Addendum 2

Project Stadium New Press Box – Marlin ISD
Issued December 8, 2023 by CEI Engineering Associates, Inc.
Proposal Opening December 14th at 2:00 PM

ADDENDUM NO. 2

PROJECT: Marlin ISD - Pressbox
HKS Project No. 26095.000

**01 TYPICAL BLEACHER-MEZZ DETAIL**

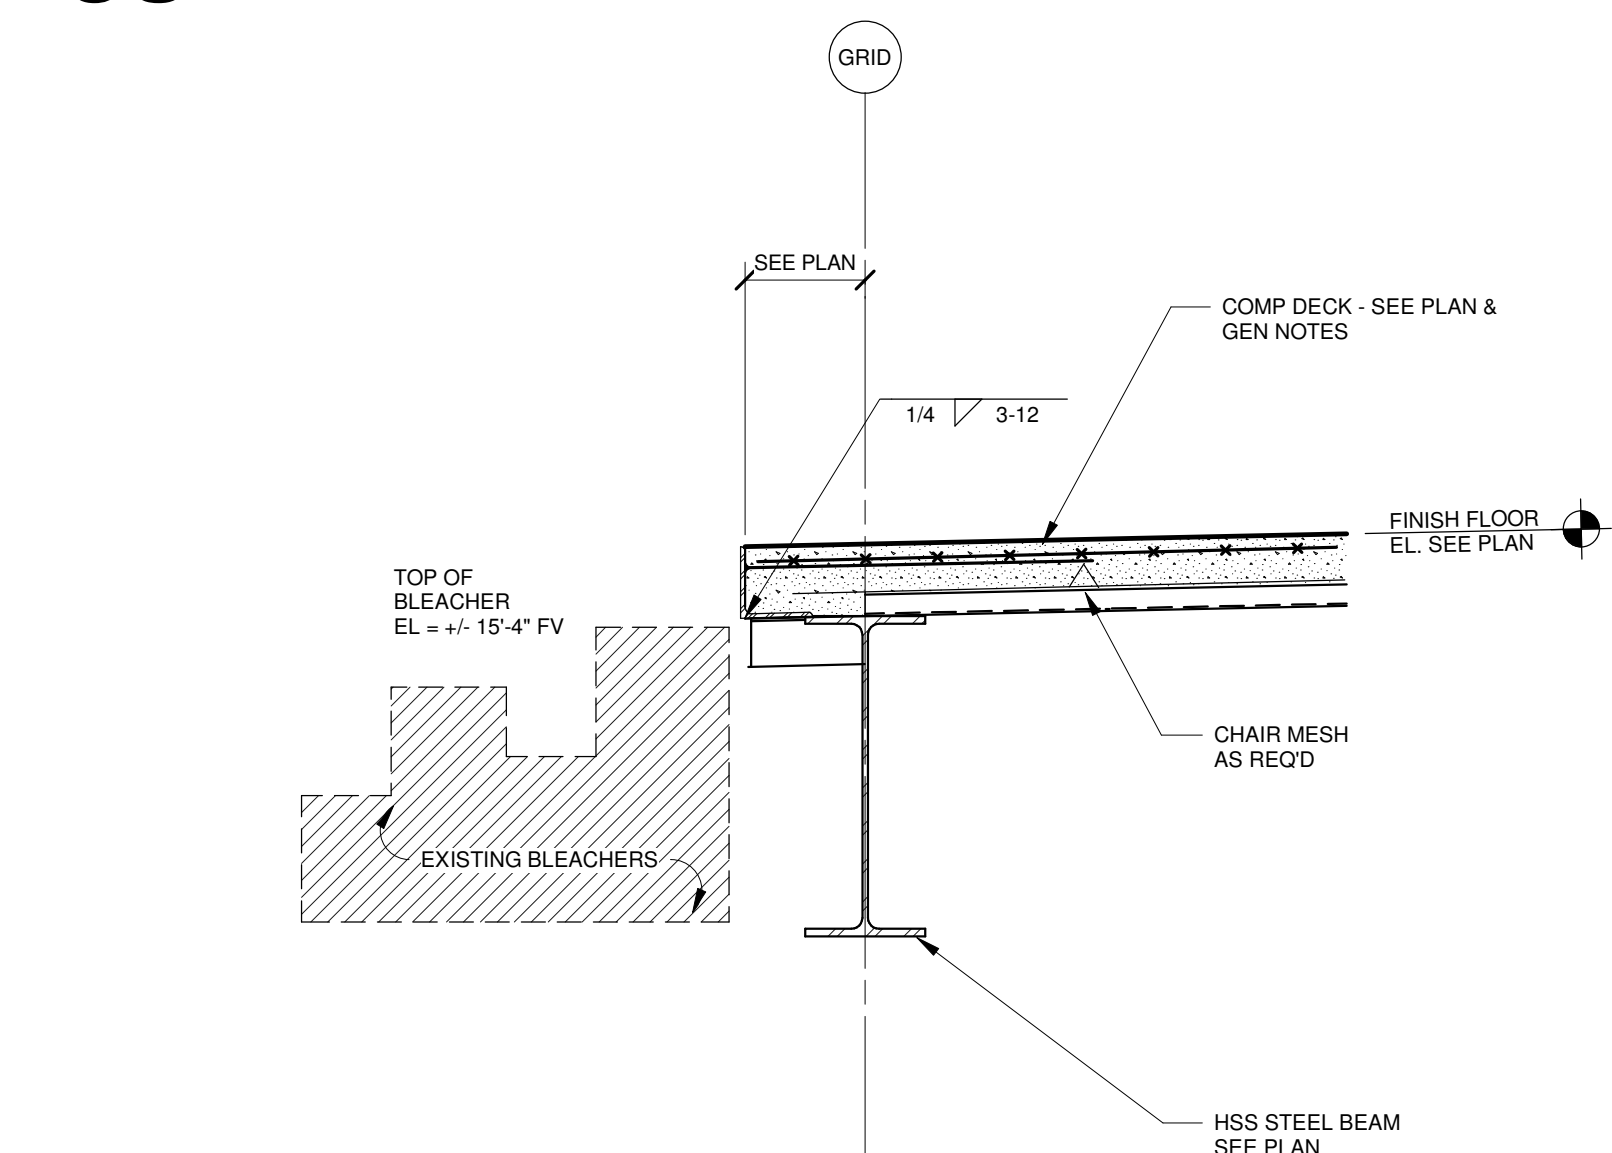
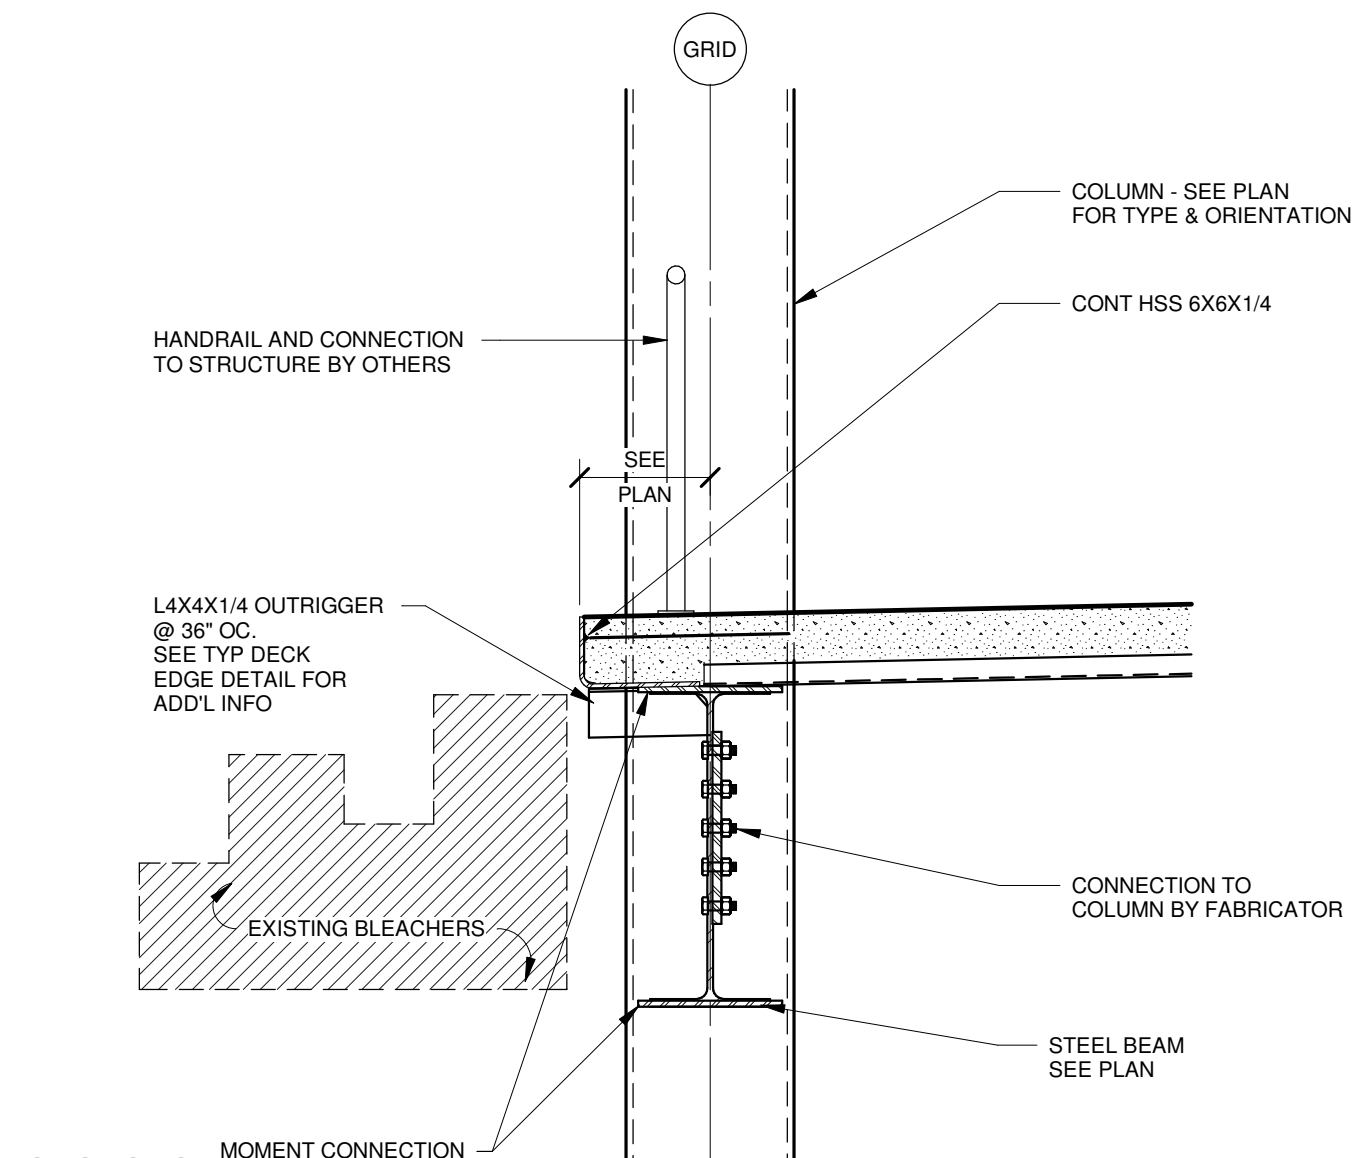
Updated 01 and 02 to reflect current bleacher-mezzanine design intent.

Updated 03 to reflect hi-low screen wall condition.

01 SECTION
3/4" = 1'-0"

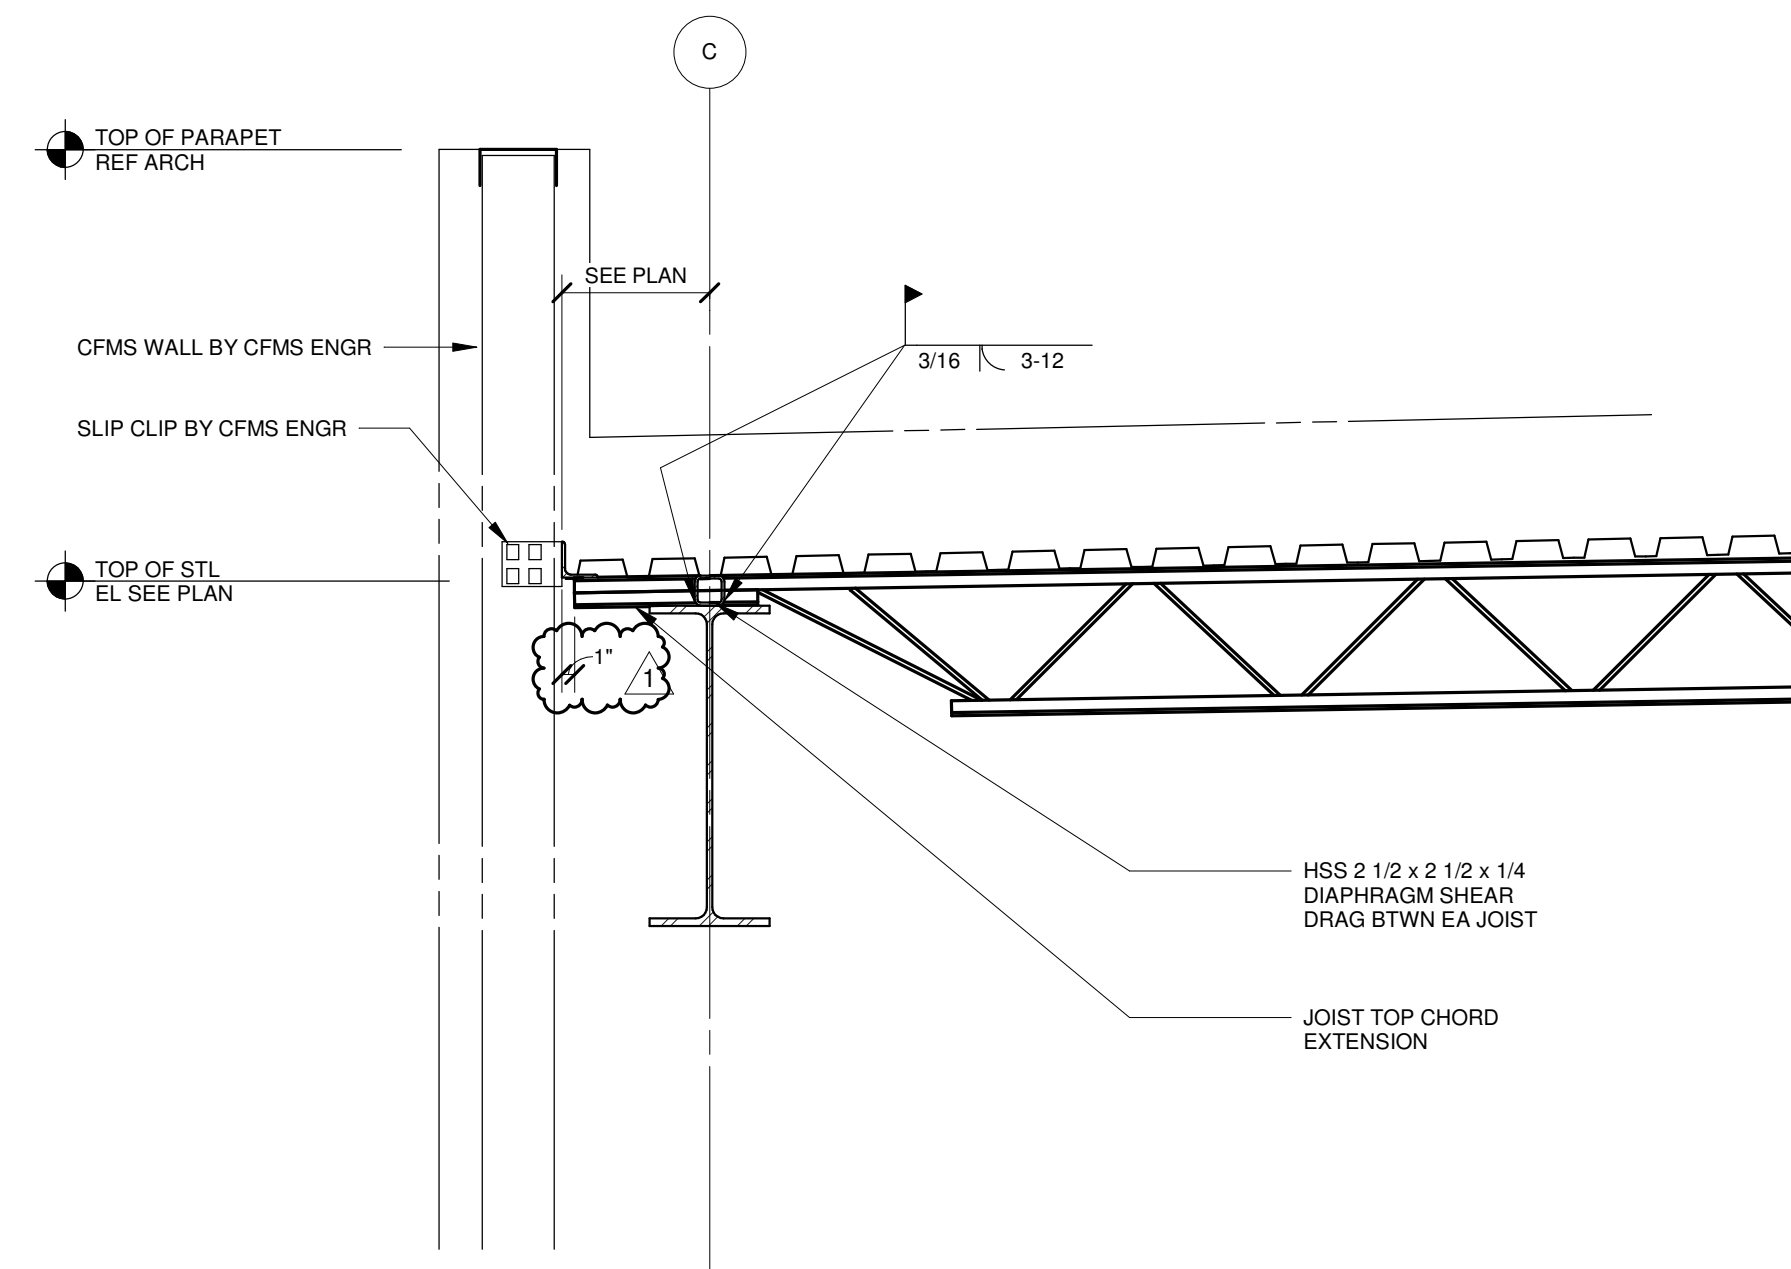
Updated detail 01 to reflect a 1" construction allowance at detail 01.
